As now amended, this application includes a single independent claim 26 in which the cover is defined as including oppositely facing side walls 46, 48 with notches 52, 54 having downwardly facing opening for receiving the base trunnions 36, 38. The surfaces defining the notches coact with the trunnions to accommodate both unimpeded vertical movement of the cover into and out of its closed position, as well as limited rotational movement about the trunnions between the closed position and an included open position. Vertical unimpeded movement of the cover is possible because the notches are substantially larger than the trunnions, and is essential in order to accommodate robotic removal and replacement of the cover.

VERSION WITH MARKINGS TO SHOW CHANGES MADE

FIG. 1

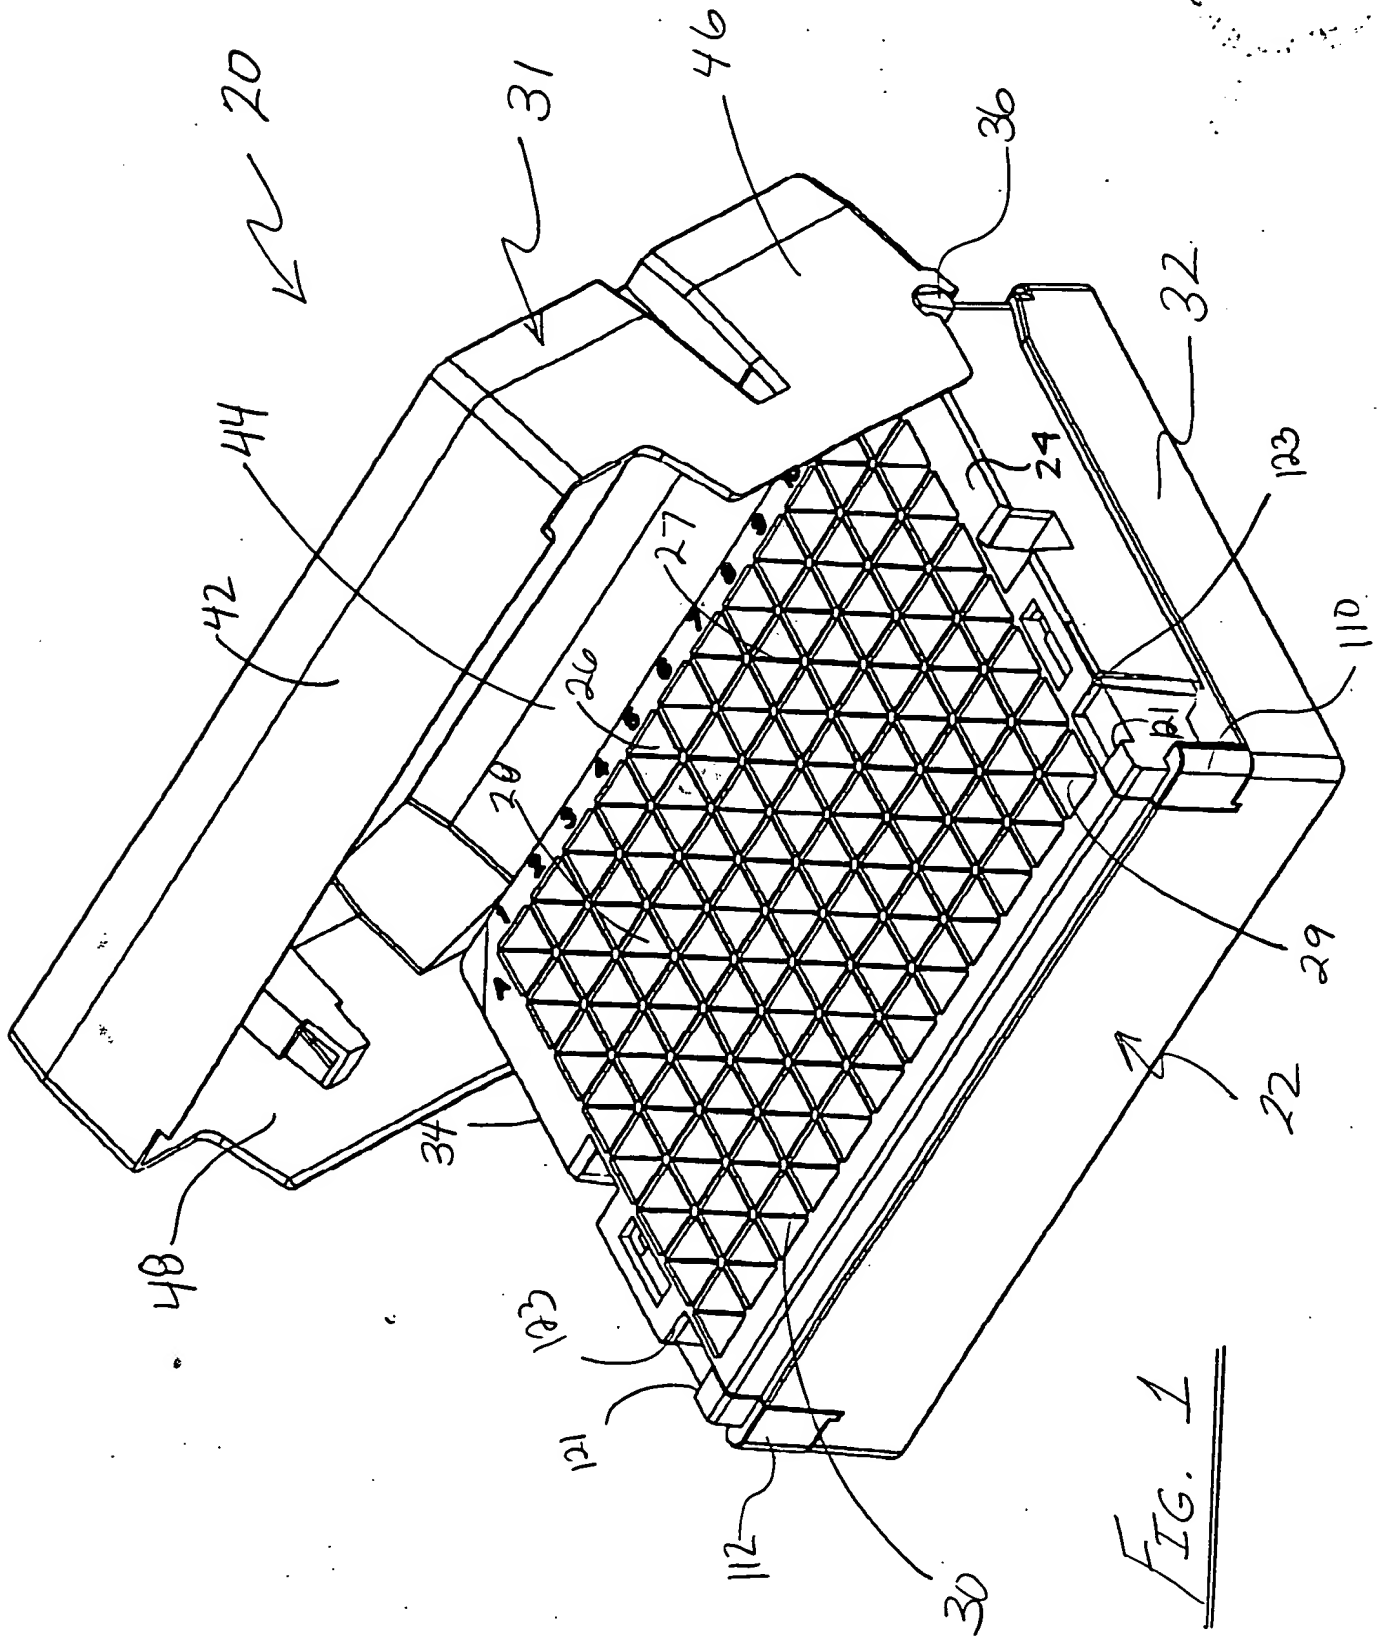
not in claim

1st disengagement is dislodge as pins disengage by an angle between 10°-90° 90° pins vertical

Not genuine can be removed

FIG. 12

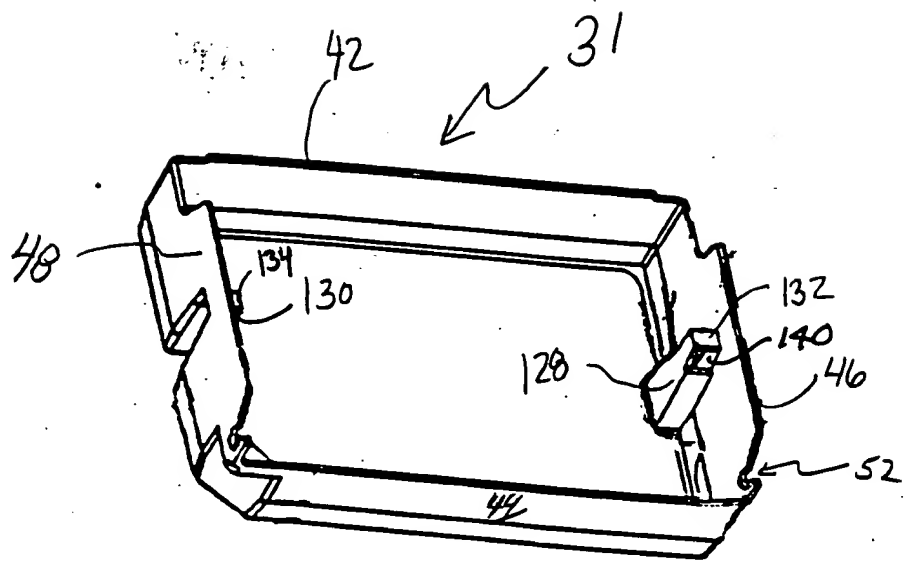
Corsi et al. (U.S. Patent No. 4,942,271) discloses a hinged plastic duct and thus its relevance to the present invention is, at best, questionable. In any event, here too the joints are characterized by snap fits, which impede free separation of the interengaged components. (see for example Col. 4, lines 1-13 regarding the embodiment shown in Figures 1-5; Col. 5, lines 16-24 regarding the embodiment shown in Figures 6-9; and Col. 6. lines 8-16 regarding the embodiment of Figures 10-13).
